Accessibility Survey

City of Downey New Street - 6th Street to 2nd Street

6th Street to 2nd Street Downey, CA 90242

Date of Inspection 7/19/2017

Change in Level North of 3rd Street @ 33.943055102720, -118.132117241621

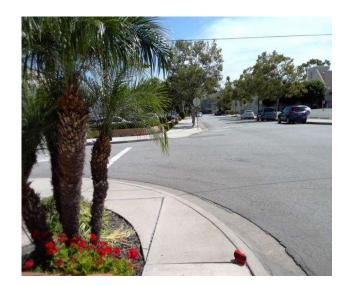
There is a change in elevation greater than recommended value.

On-Site Finding 0.50 inches

Ensure that the change in elevation is within the recommended value.

Recommendation Up to 0.25 inches

Change in Level North of 4th Street @ 33.943504580145, -118.131725639105

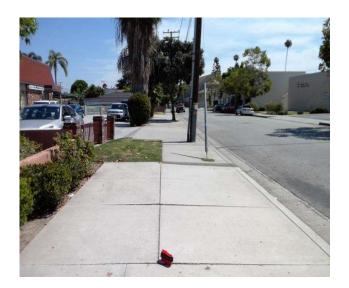
There is a change in elevation greater than recommended value.

On-Site Finding 0.62 inches

Ensure that the change in elevation is within the recommended value.

Recommendation Up to 0.25 inches

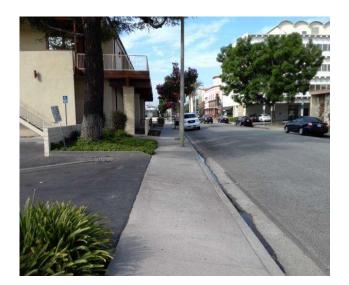
There are no detectable warnings where the pedestrian route crosses vehicular traffic.

On-Site Finding Not Found

Provide detectable warnings.

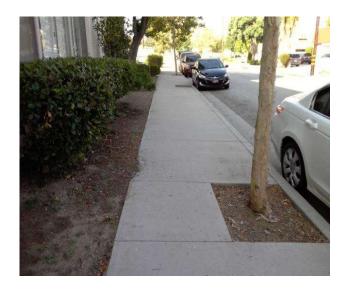
Sidewalk does not have enough width.

On-Site Finding 42.00 inches for 4.00 feet

Widen the sidewalk to the recommended value.

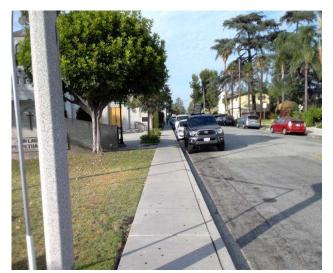
Sidewalk cross slope is not compliant.

On-Site Finding 5.30 percent for 320.00 feet

Repave the sidewalk surface with the recommended cross slope.

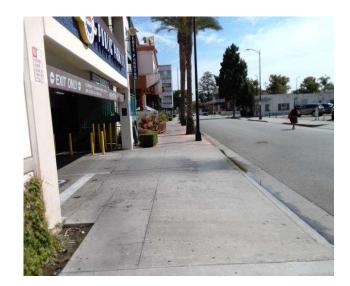
There are no detectable warnings where the pedestrian route crosses vehicular traffic.

On-Site Finding Not Found

Provide detectable warnings.

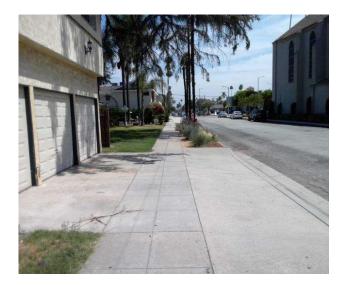
There are no detectable warnings where the pedestrian route crosses vehicular traffic.

On-Site Finding Not Found

Provide detectable warnings.
